WHITEHAVEN COAL

RE: NARRABRI MINE MODIFICATION 5 – RESPONSES TO SUBMISSIONS

ATTACHMENT 1
RESPONSES TO SUBMISSIONS

Re: **Narrabri Mine - Longwall Panel
Width Modification – Groundwater
Modelling Assessment - Response
to DPI Water**

Figure 1. Estimated pre-mining water table contours (mAH): [a] Observed; [b] Simulated

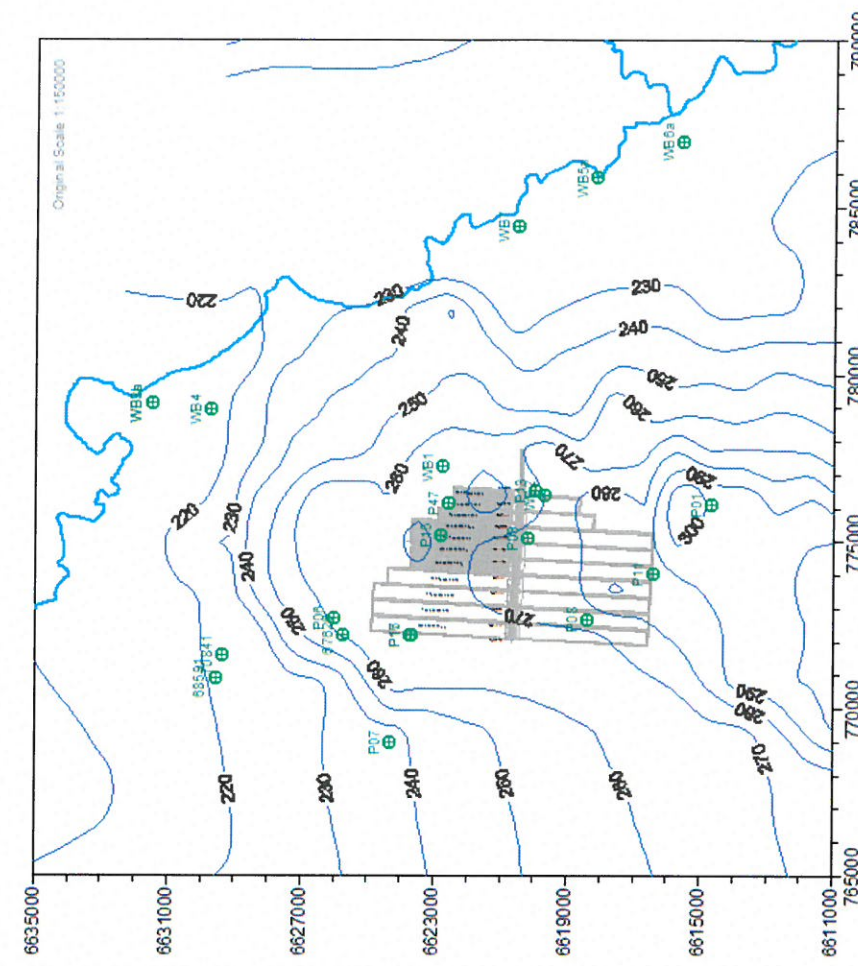
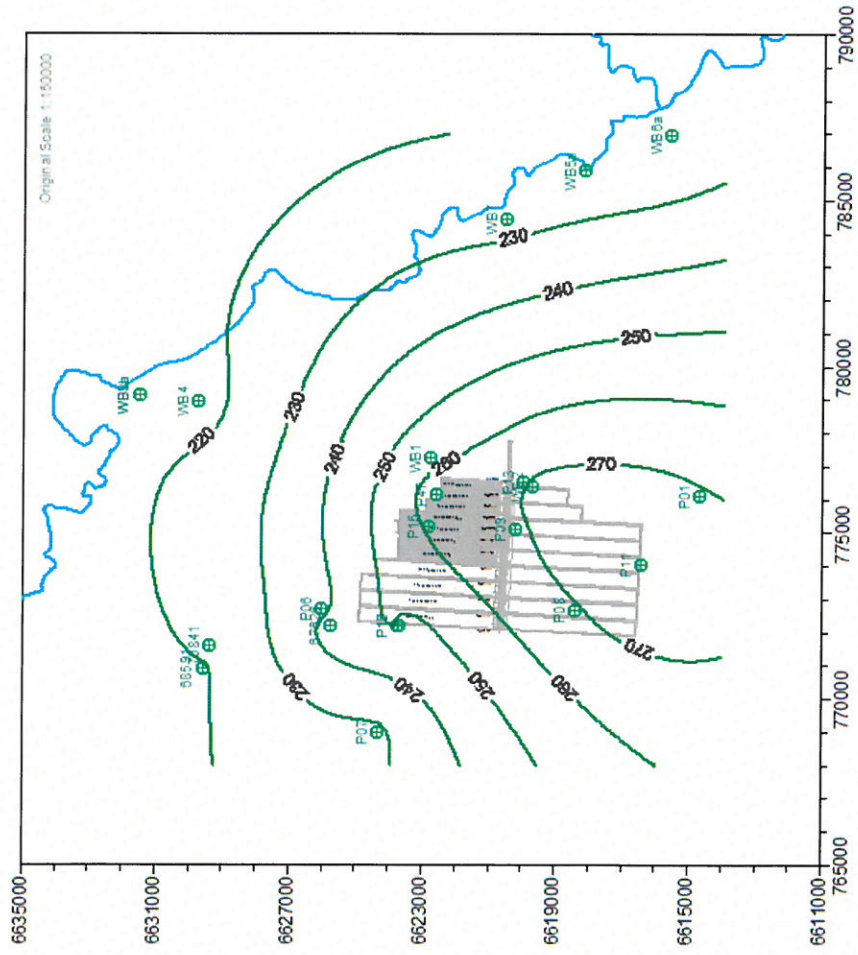
Clarify the discrepancy in the groundwater model of the 15 metres between the modelled and observed initial heads. The modelled initial head needs to reflect as close as possible to the observed initial head.

This comment relates to bore P6 in particular, rather than a general observation at all bores. Bore P6 is placed in the Pilliga Sandstone. While there are some discrepancies at standpipes, there is exceptionally good calibration of vibrating wire hydrographs where mining effects have been observed. The discrepancy at P6 is not due to "use of interpolated heads as initial heads" or boundary conditions, as suggested. The general head boundary conditions at the north-western corner of the model have been checked and confirmed to be appropriate. The initial heads are derived from an optimal steady-state calibration.

Standard practice in mining models is to apply a uniform permeability to a given lithology. That has been done here. The setting at P6 is the best that could be achieved with this assumption. As P6 is in the outcropping Pilliga Sandstone, its water level reflects the water table. A best estimate of the regional water table, based on pre-mining field measurements, is shown in Figure 1 [a]. The simulated pre-mining water table is shown in Figure 1 [b]. The patterns agree very well. With an assumption of uniform permeability for Pilliga Sandstone, the model generates a steep hydraulic gradient in the vicinity of P6 and a fairly flat gradient over the northern half of the mine footprint. Better representation of the hydraulic gradient would require localised variations in permeability. The variable hydraulic gradient is responsible for the offset simulated at P6.

Absolute offsets in simulated heads are not a serious issue when the objective is the estimation of impacts, in the form of drawdowns or water level differences due to alternative mine plans, as is the case here.
